**STRUCTURAL TECHNICAL REPORT NO. 035**

**Project:** WTLP New Cargo Study

**Subject:** Berth 2 Foundation Retrofits - Basis of Design

RE: Review of Westshore Berth 2 Retrofit – Path to Code Compliance

Figure 1. Diagram showing the options for soil densification

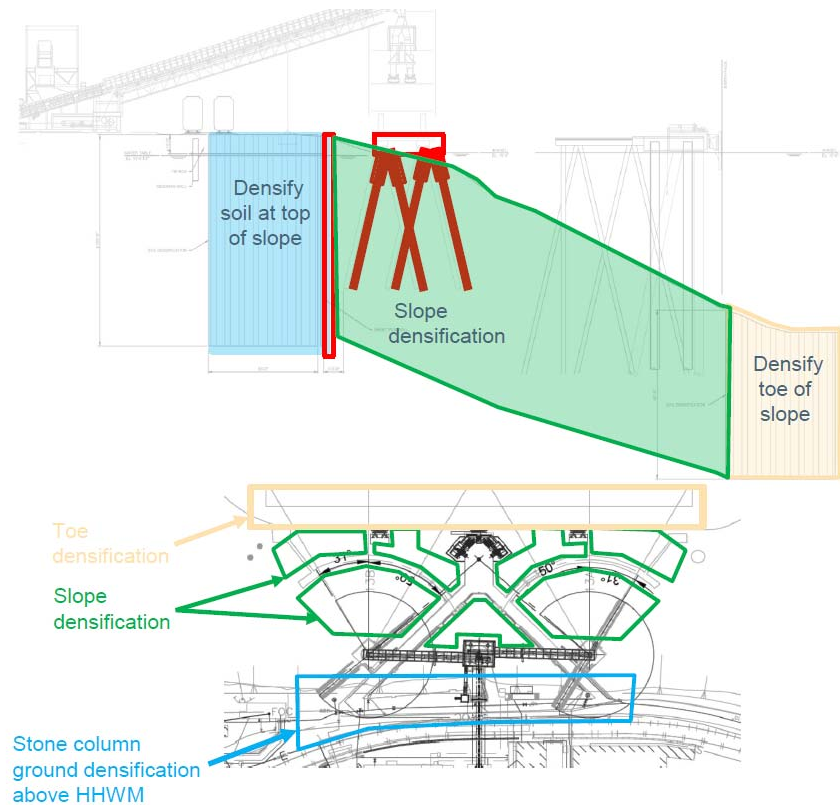
Figure 1 below shows the options that have been reviewed by Westshore for the soil/ground improvement of Berth 2. Ultimately, Westshore proposal will be limited to densification at the top and the toe of the slope due to valid concerns about the effects of densification around existing structures within the slope.

**JH Comment:** This is a reasonable approach, especially when the seismic event for which the structural performance is targeted, has a return period of 1:225-years.
